DEVELOPMENT APPLICATION

APPLICATION NUMBER:	PLN-24-156
PROPOSED DEVELOPMENT:	Two lot subdivision
LOCATION:	5 Second Avenue West Moonah
APPLICANT:	S R Pulford
ADVERTISING START DATE:	24/07/2026
ADVERTISING EXPIRY DATE:	07/08/2026

JMG Engineers have been engaged on behalf of the developer to provide the design for stormwater surface drainage, including a proposed pump station and associated storage for each lot to collect and remove surface water from the proposed subdivision at 5 Second Avenue.

RFI RESPONSE
5 Second Avenue, West Moonah
PLN-24-156

JOB NAME: #####	DRAWN BY: SP		CHECKED BY: CHCK	
					DESCRIPTION: PROPOSED 1 LOT AND BALANCE SUBDIVISION 5 SECOND AVENUE, WEST MOONAH.	SCALE: 1: 200			
						DATE: 17 APRIL 2024			
						JOB NUMBER		SHEET	Size
							1 of 9	A3	
					DRAWING: LOT LAYOUT				
		NO: CHANGE		CKD	DATE

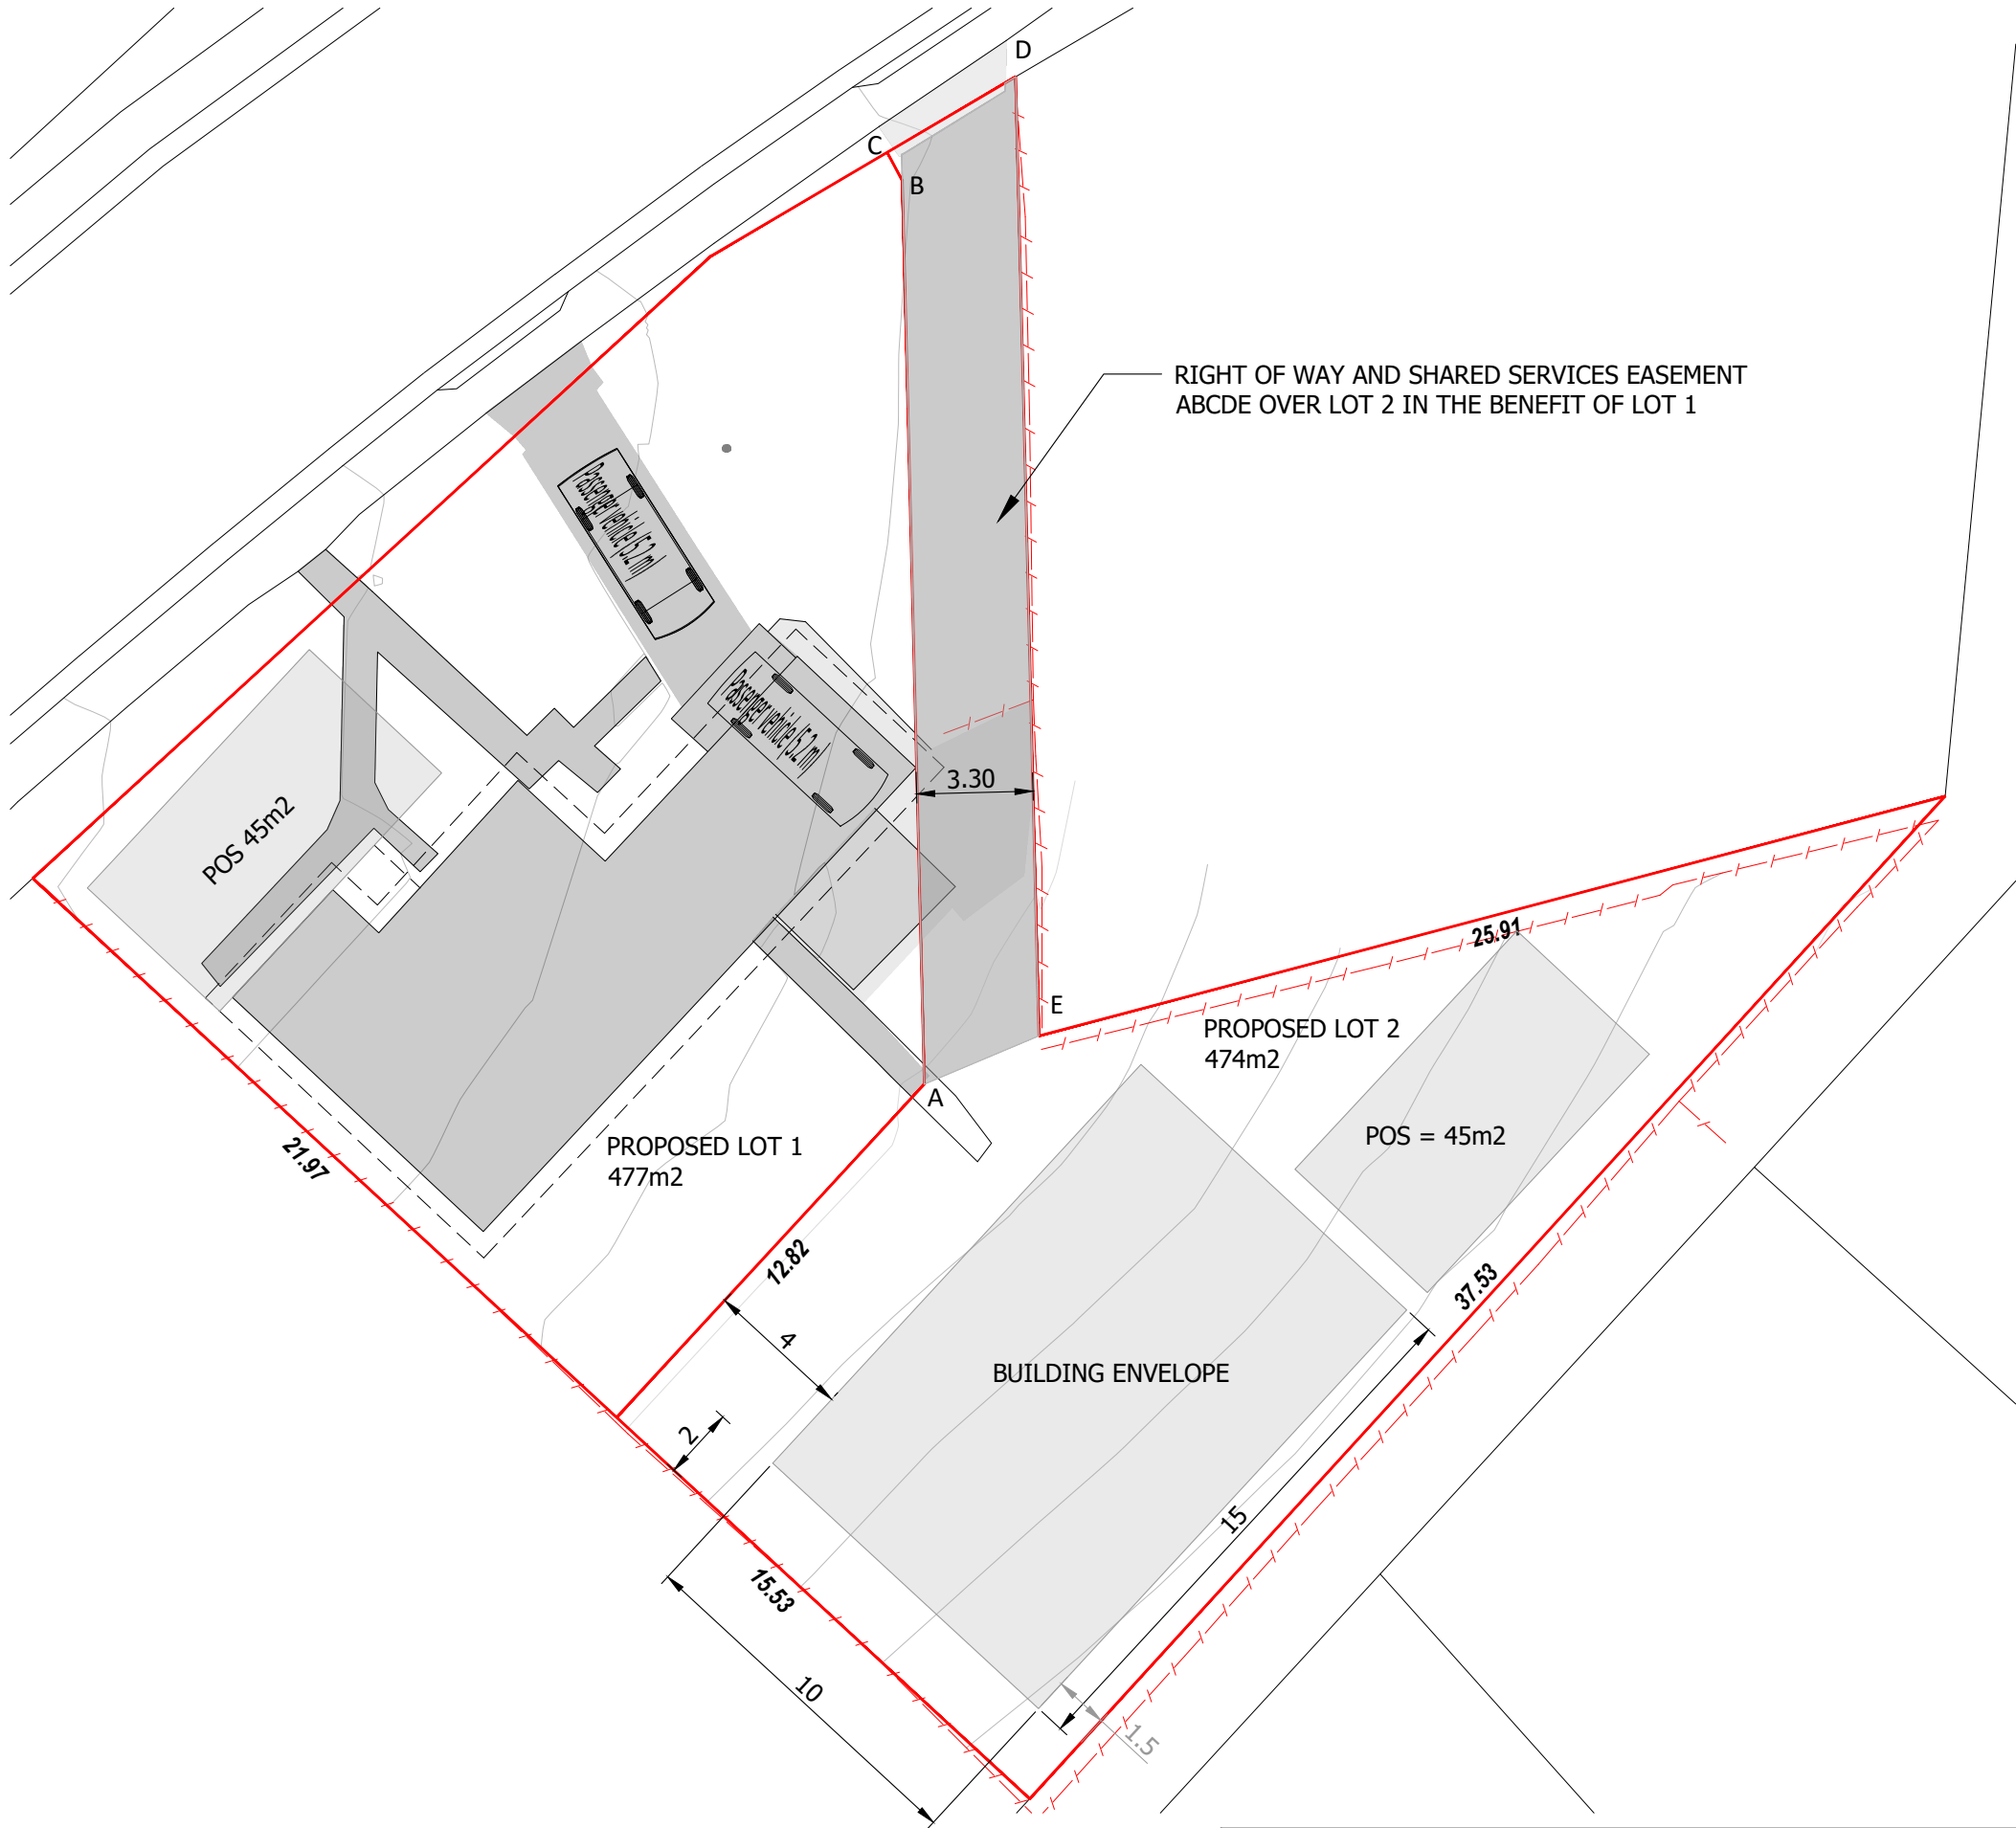
- 2. *On the plan of subdivision, please clearly show the Stormwater connection to each lot to Council's satisfactory. The connections to public stormwater system must be contained wholly within each new lots served and entirely separated or covered by appropriate easements. Stormwater connections must be located at the lowest point of the new lot.*
 - a. *Clarify if stormwater pipe and connection for Lot 1 will be over the boundary and onto lot 2 driveway, see below. Services to each lot must be wholly contained within the lot and entirely separated. Submit amended plans or show easements.*

Not satisfied – pipes shall be contained wholly within each lot or within appropriate easements.

7. Please demonstrate two (2) compliant car parking spaces for the existing house; and locate them on the plan.

Not satisfied – Locate 2 compliant car parking spaces for the existing dwelling on the plan.

The plans have been amended to clearly show the alignment of the SW and shared services easement over the Lot 2 access (sheet 1 of 9).

Sheet 1 of 9 has been updated to show two car parking spaces on the plan.

JOB NAME: #####	DRAWN BY: SP	CHECKED BY: CHCK	
						DESCRIPTION: PROPOSED 1 LOT AND BALANCE SUBDIVISION 5 SECOND AVENUE, WEST MOONAH.	SCALE: 1: 200		
							DATE: 17 APRIL 2024		
							JOB NUMBER	SHEET	Size
								3 of 9	A3
	NO: CHANGE		CKD	DATE	DRAWING: SEWER AND WATER LAYOUT

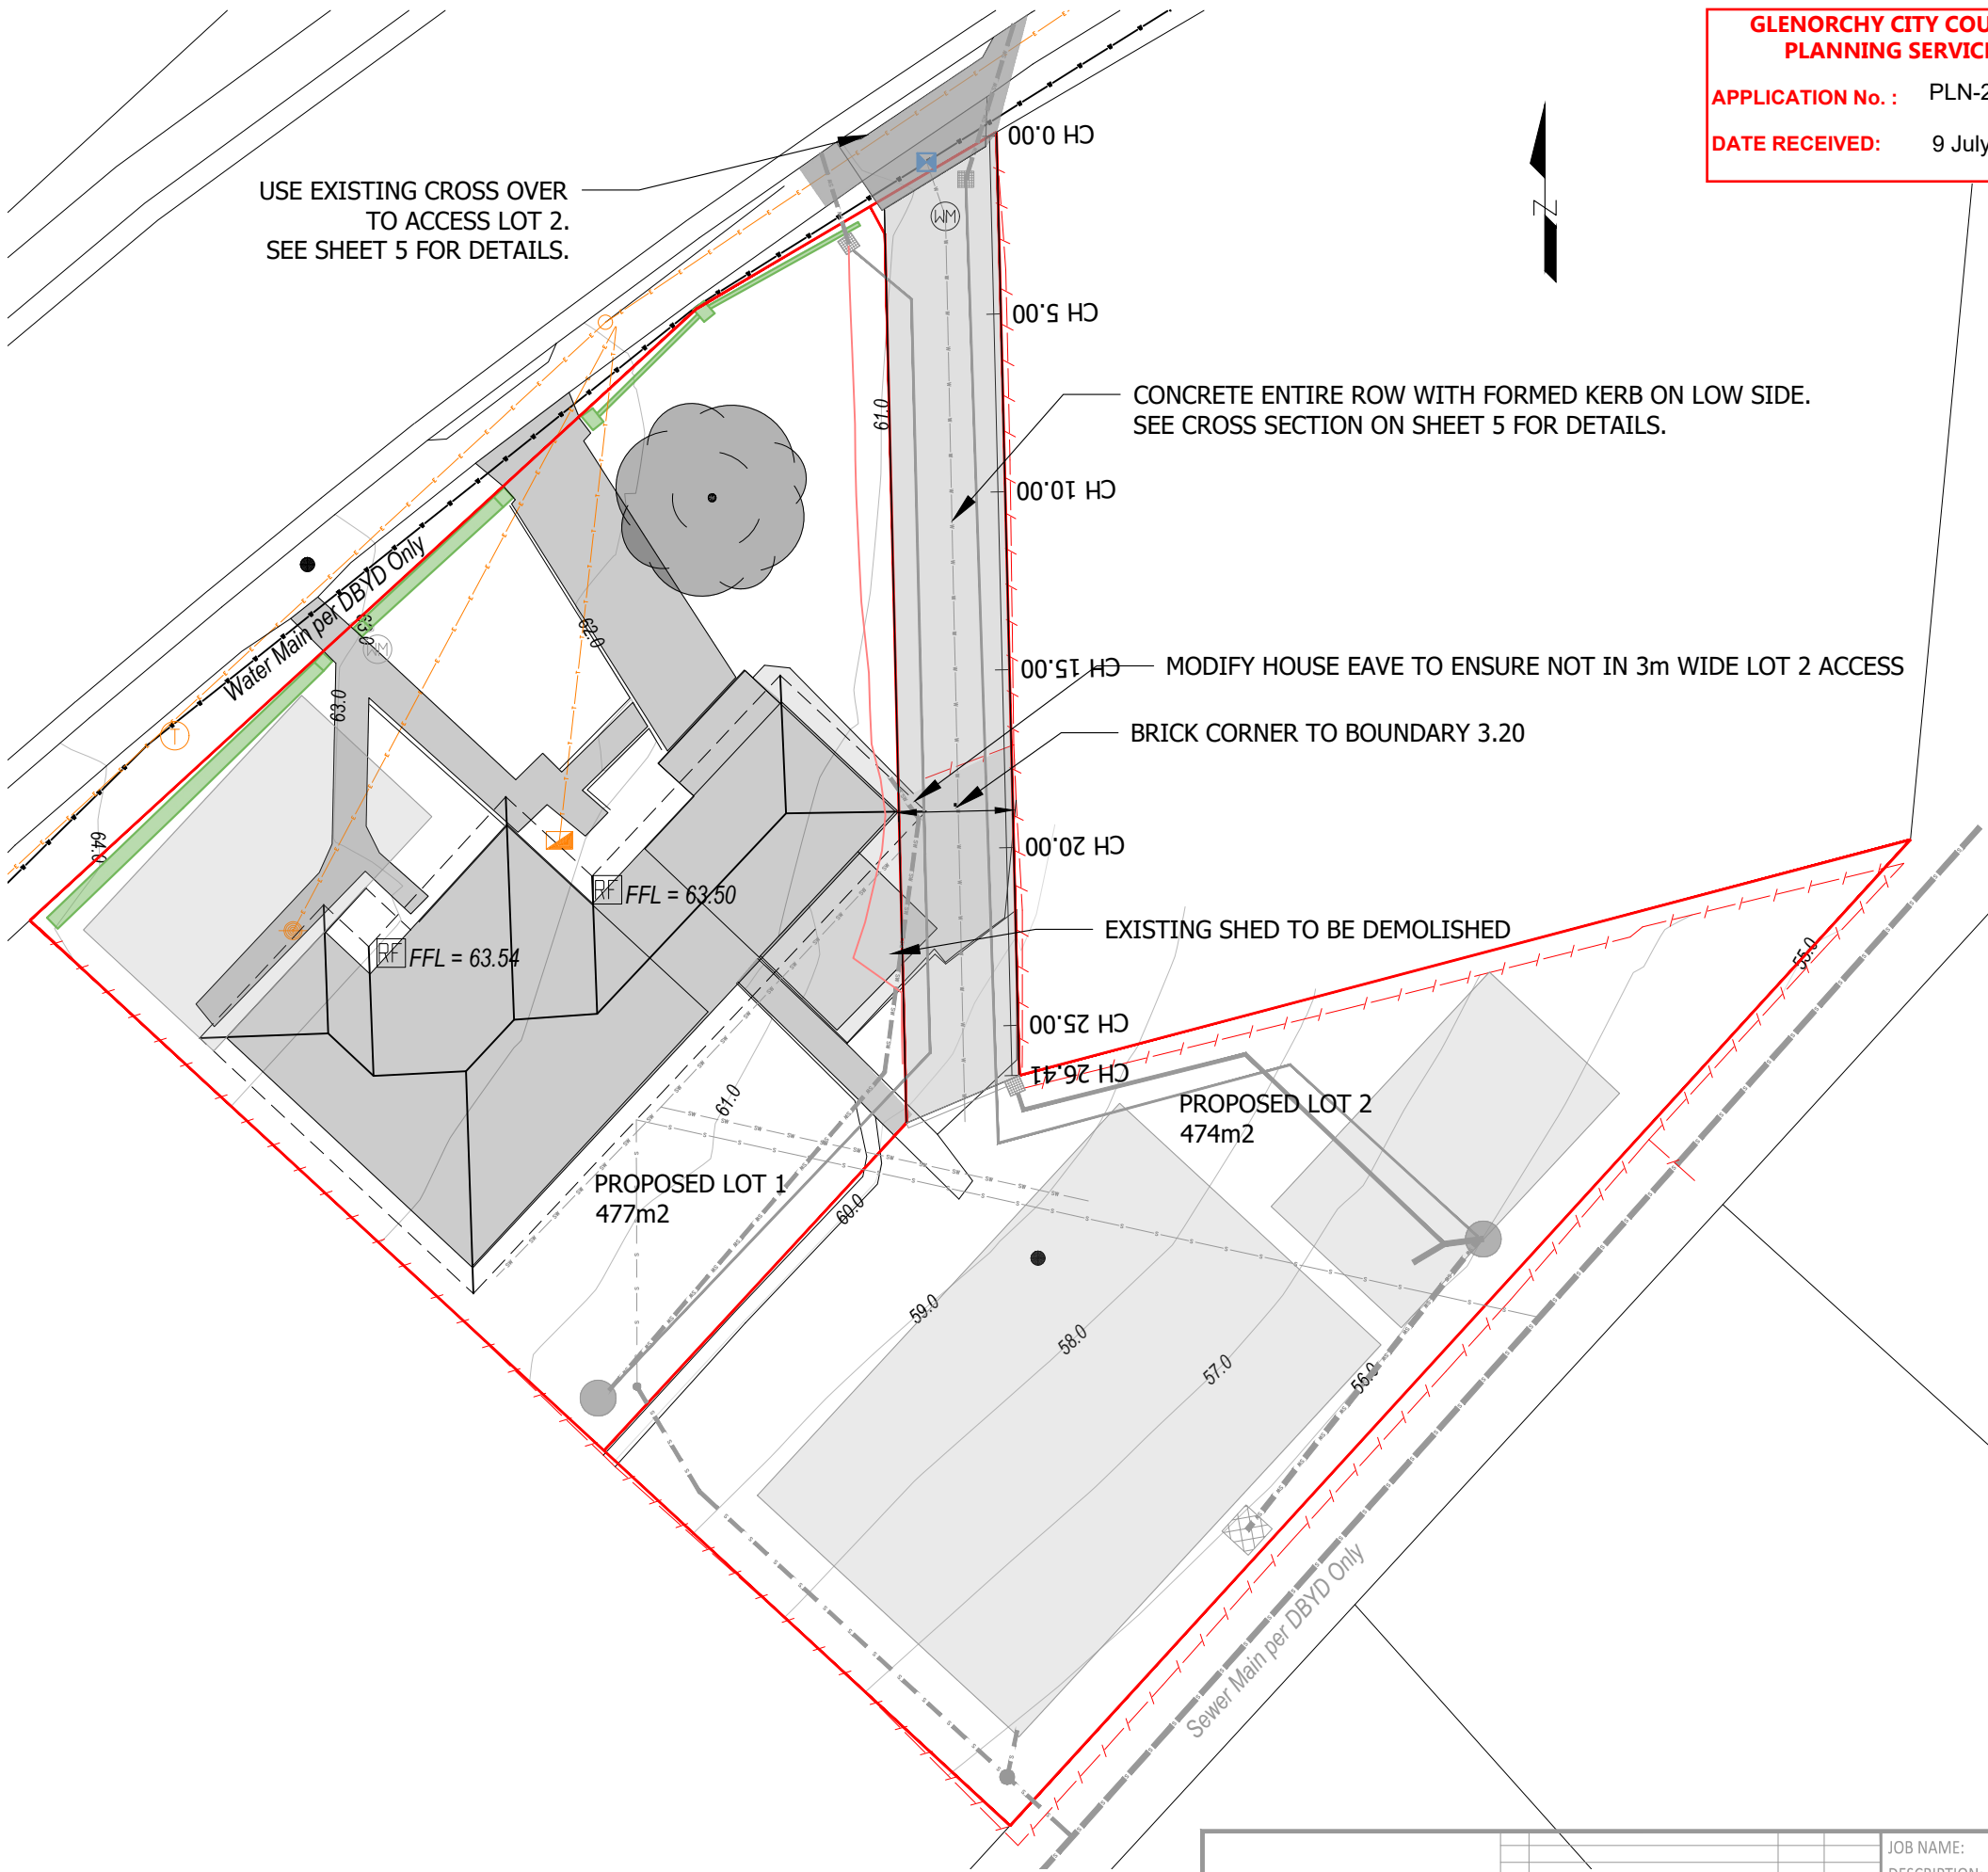
Additionally, parking area runoff concept plan shall also be provided.

8. *Satisfied.*
9. *Please provide a stormwater concept plan showing the capture and disposal of stormwater run-off from the proposed driveway and the extended driveway to garage/carport. A stormwater concept plan showing the capture and disposal of stormwater run-off from the proposed driveway, parking and any new hardstand areas for each lot to Council's approved outlet is required.*

Not satisfied – no concept stormwater plan for driveway provided.

The stormwater layout plan (Sheet 2 of 9) has been amended to show drainage for the proposed Lot 2 driveway (ie a pit at the bottom of the drive). No parking areas are provided to Lot 2 as part of the subdivision. Parking areas for Lot 2 will be designed at the time of further development of the lot. There is sufficient space to provide 2 car parking spaces on Lot 2.

As noted above, the stormwater layout plan (Sheet 2 of 9) has been amended to shown drainage for the proposed Lot 2 driveway (ie a pit at the bottom of the drive).

JOB NAME: ##### DESCRIPTION: PROPOSED 1 LOT AND BALANCE SUBDIVISION 5 SECOND AVENUE, WEST MOONAH.	DRAWN BY: SP		CHECKED BY: CHCK		
					SCALE: 1: 20				
					DATE: 4 MAY 2026				
					JOB NUMBER		SHEET		Size
							8 of 9		A3
	NO: CHANGE	CKD	DATE	DRAWING: DETAILS

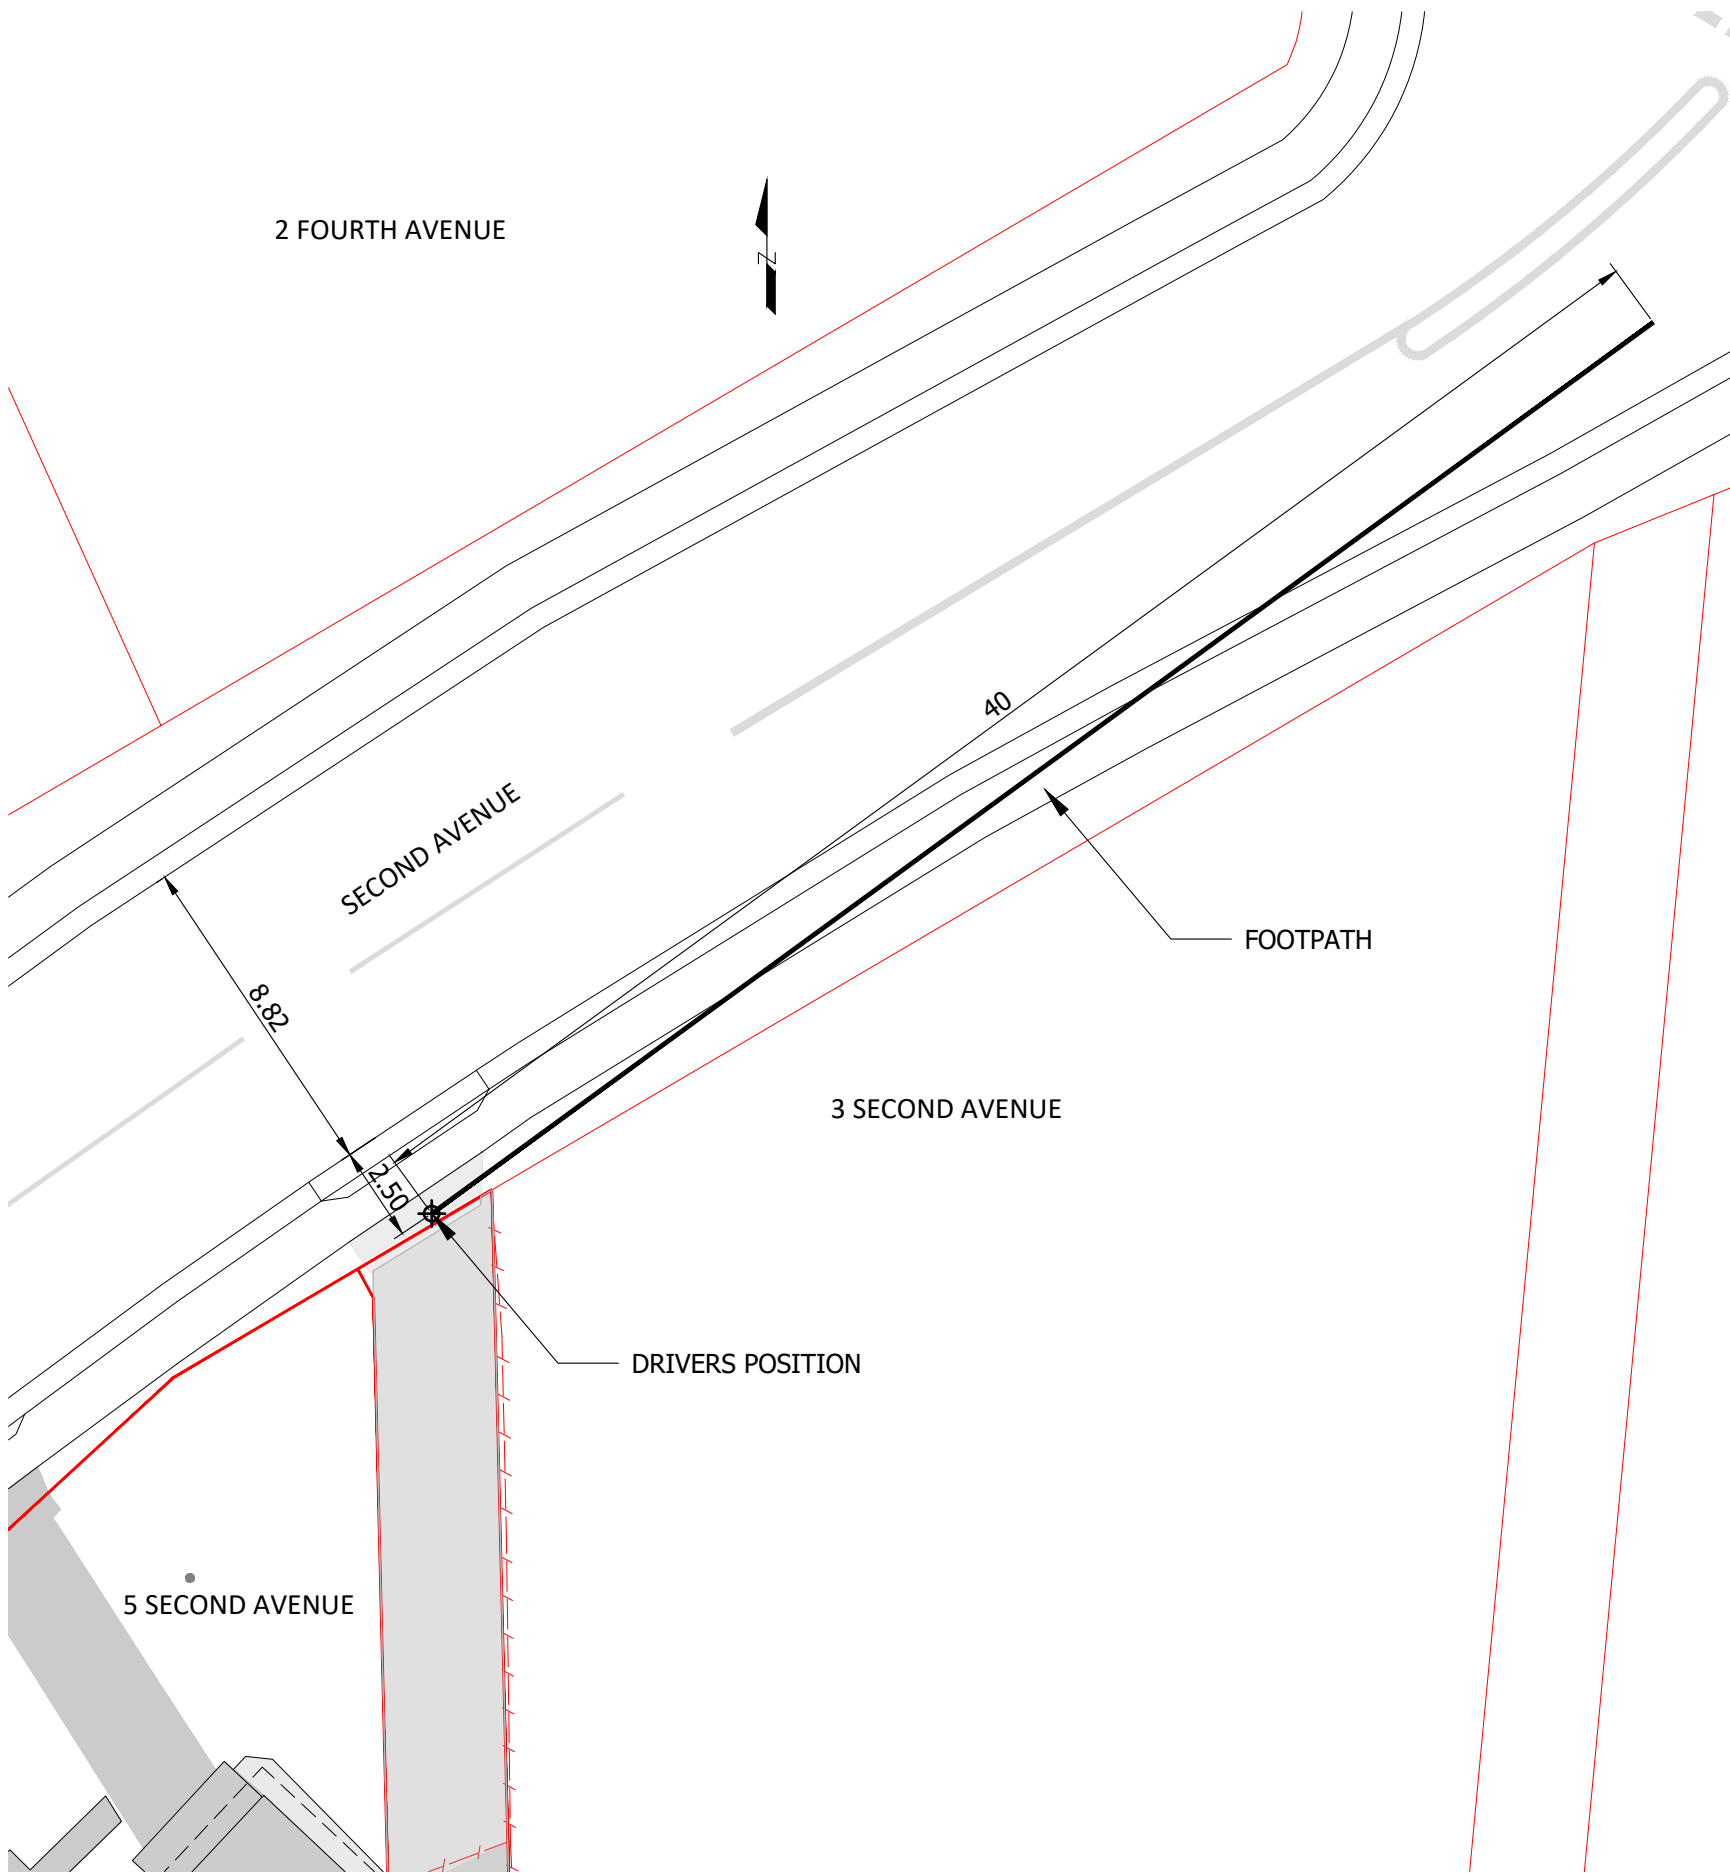
- b. Show details of the proposed stormwater lot connections including the kerb construction over the driveway access of lot 2.

Not satisfied – no details of SW connection's type, size and material on the plan.

Details of the proposed stormwater lot connection have been provided at Sheets 7 and 9 of the Subdivision Plans.
